**METROPOLITAN GOVERNMENT OF NASHVILLE AND DAVIDSON COUNTY**

**STAFF RECOMMENDATION**  
**207 Gentry Avenue**  
**October 15, 2014**

**Application:** New construction—addition and infill; Partial demolition  
**District:** Eastwood Neighborhood Conservation Zoning Overlay  
**Council District:** 06  
**Map and Parcel Number:** 08306020500  
**Applicant:** Andrew Beairo, Gentry Partners  
**Project Lead:** Melissa Baldock, melissa.baldock@nashville.gov

**Description of Project:** Application is to demolish a non-contributing addition and construct a new addition to a contributing structure (207 Gentry), three infill houses, four garages, and six rear lot cottages as part of a cottage development.

**SP Layout**

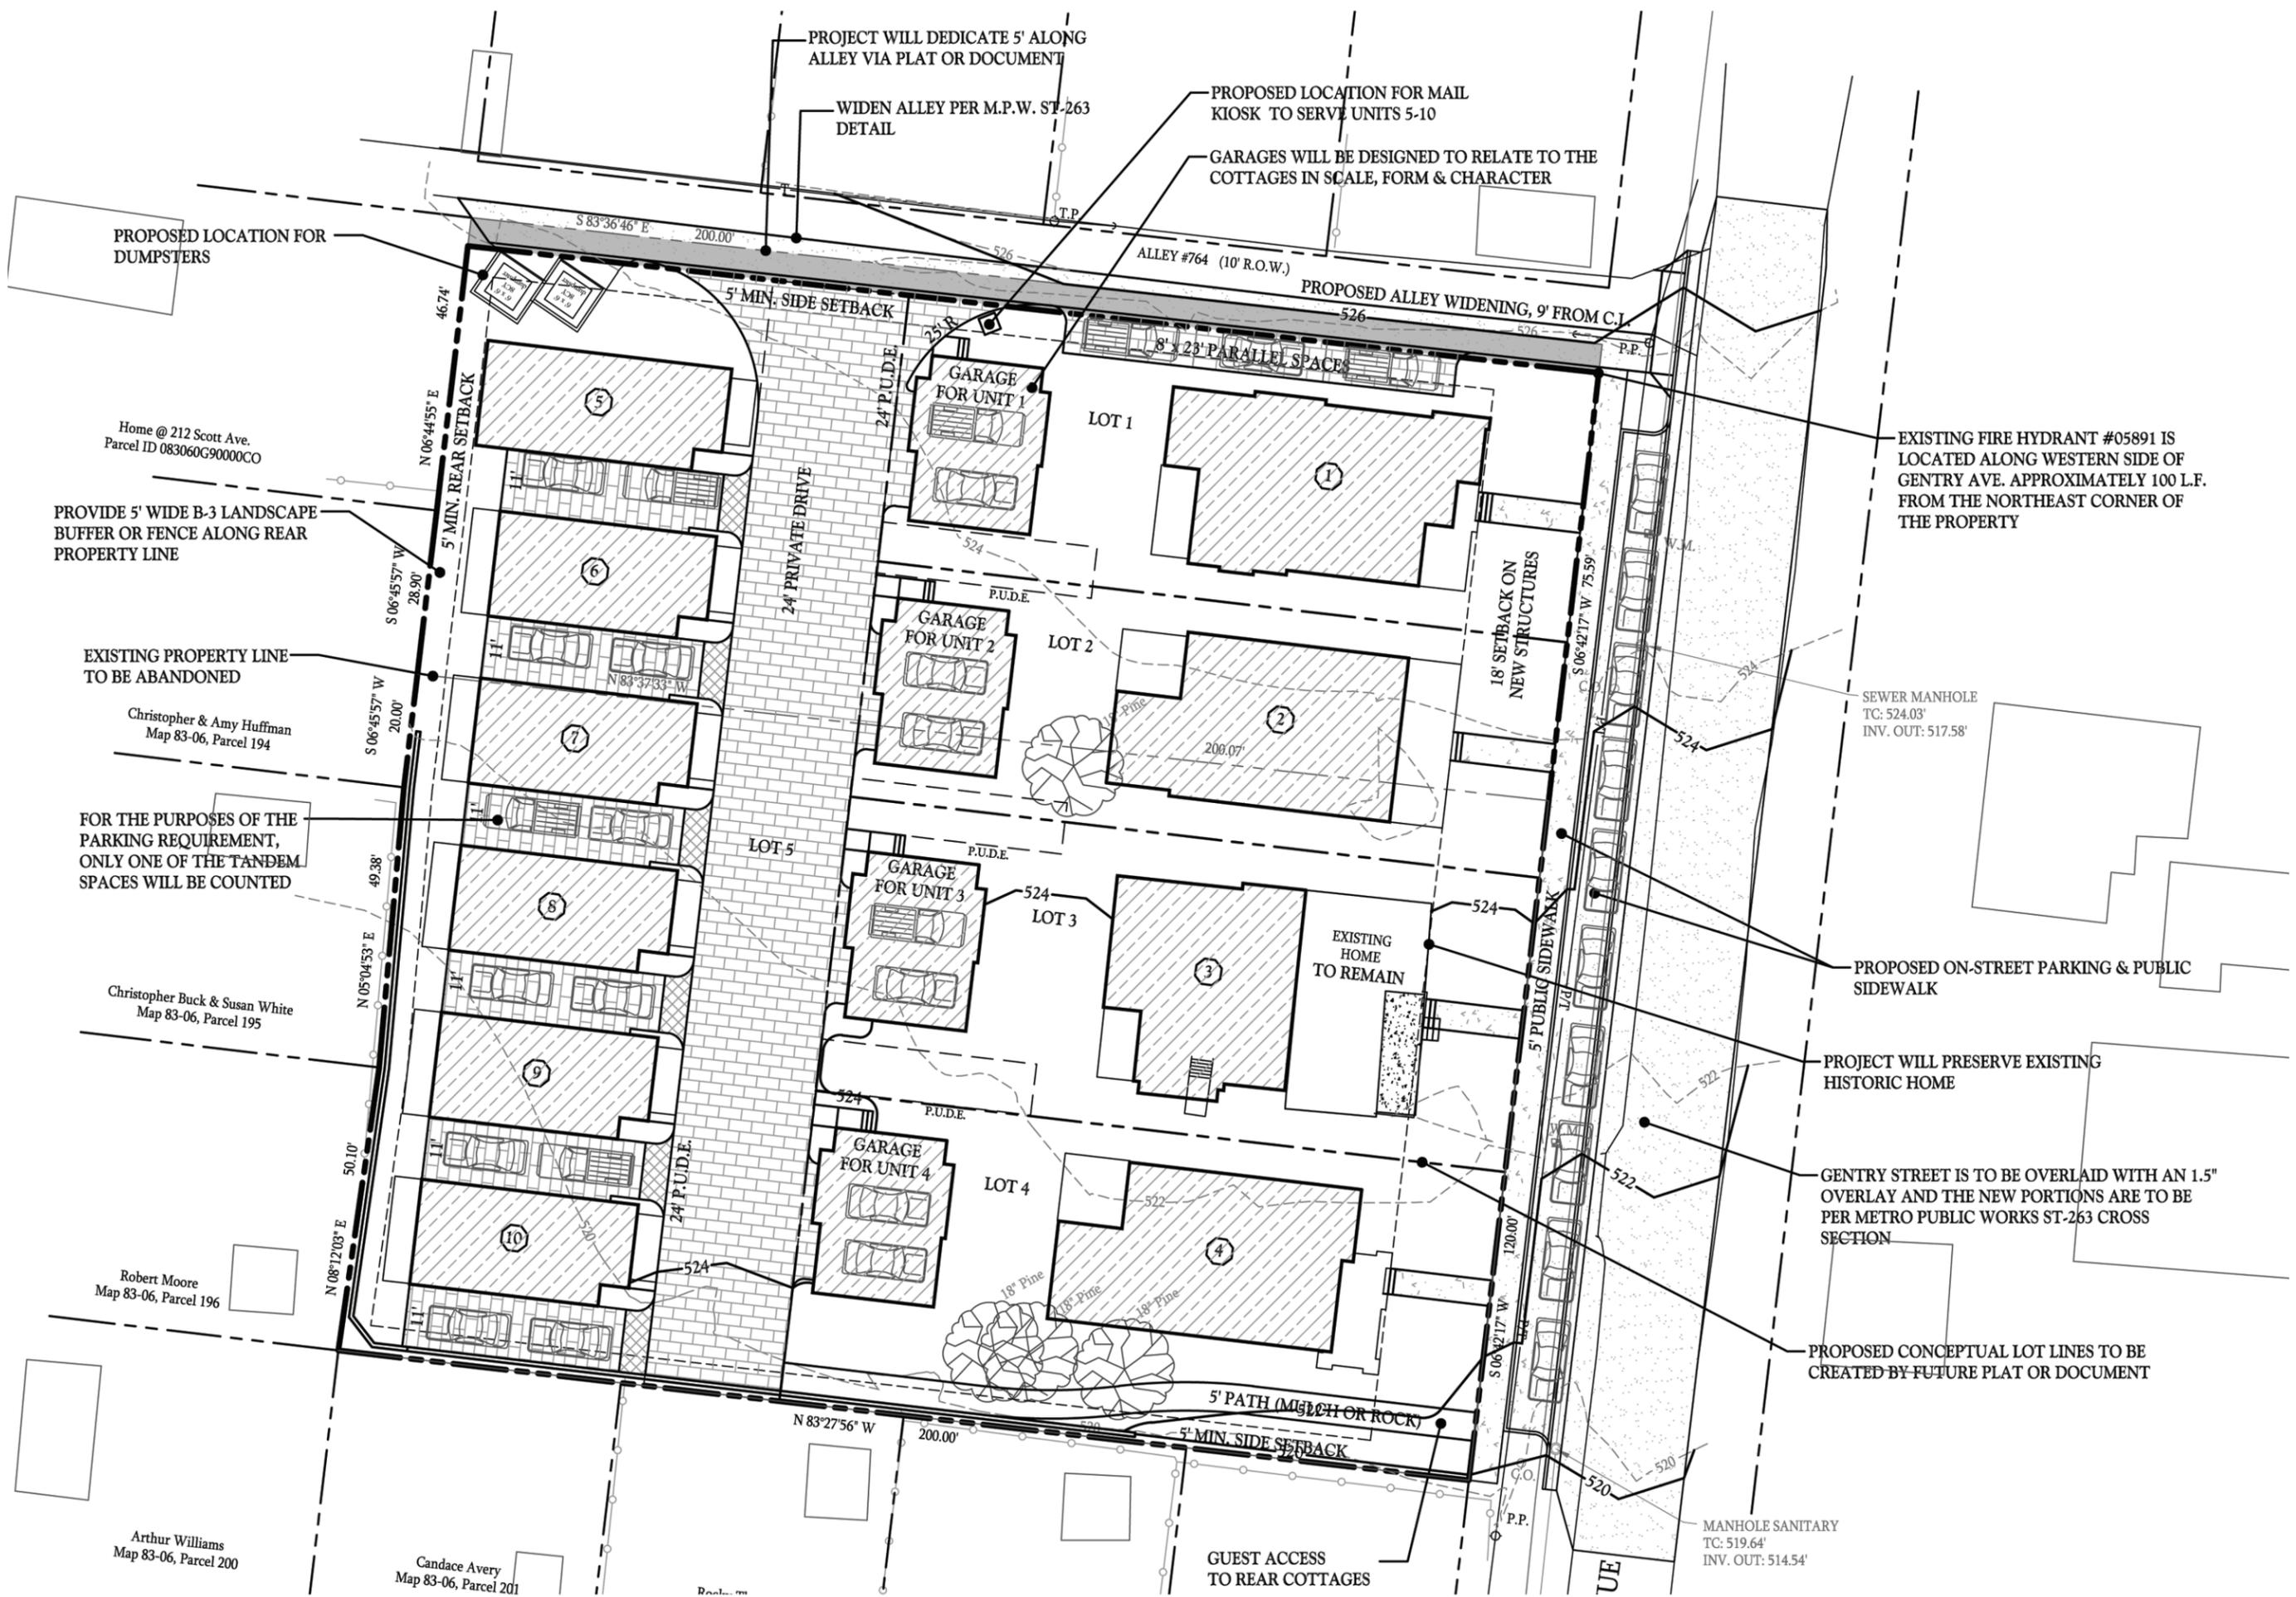
**Site Plan, Location, Setbacks, Rhythm of Spacing, Orientation, and Parking.** At the front of the site, the historic house at 207 Gentry Avenue will be retained with a new addition, and three new detached single family houses will be constructed to its sides (Figure 3). Because the lot is two hundred feet (200') wide, each house will have approximately fifty feet (50') of street frontage. This will approximate the rhythm of spacing of the Eastwood neighborhood, where typical lots are fifty feet (50') wide with ten to twenty feet (10'–20') of space in between the houses.

Behind the four primary houses facing Gentry Avenue will be four two-story garages. These garages will be no wider than the houses facing Gentry Avenue, and will line up behind them in order to decrease their visibility from the street. The garages will serve the front units.

Behind the garages, parallel to Gentry Avenue, the applicant proposes to create a new twenty-four foot (24') wide private drive or alley. The drive will connect to the alley at the side of the property. It will provide vehicular access to the garages for the front units, and will provide both pedestrian and vehicular access to the six new cottages proposed for the rear of the site. The drive will be located behind the midpoint of the site, decreasing its visibility from the street.

At the rear of the lot will be six cottages that will be accessed via the new private drive and will be oriented towards the drive. The visibility of these units will be minimal from Gentry Avenue, as they will be located approximately one hundred and fifty feet (150') behind the front property line. Most of the cottages will be ten feet (10') from the rear property line, but the cottage closest to the existing alley (#5), will be five feet (5') from the rear property line. Cottage 5 will be approximately fifteen feet (15') from the alley/side property line, and Cottage 10 will be approximately ten feet (10') from the

south side property line. Parking for the rear units will be uncovered parking pads in between the units which will provide spaces for two cars per unit (or 12 spaces total). Three additional parallel parking spaces will be located off of the existing alley to the right of House 1.

Utilities: The location of the HVAC and other utilities for the infill units were not specified on the site plan. Staff asks that the HVAC units be located on the rear façades, or on a side façade beyond the midpoint of the houses.

5. All horizontal lap siding on all new construction have a maximum reveal of five inches (5");
6. The HVAC units for the primary houses facing Gentry Avenue be located behind the house or on either side, beyond the mid-point of the house;
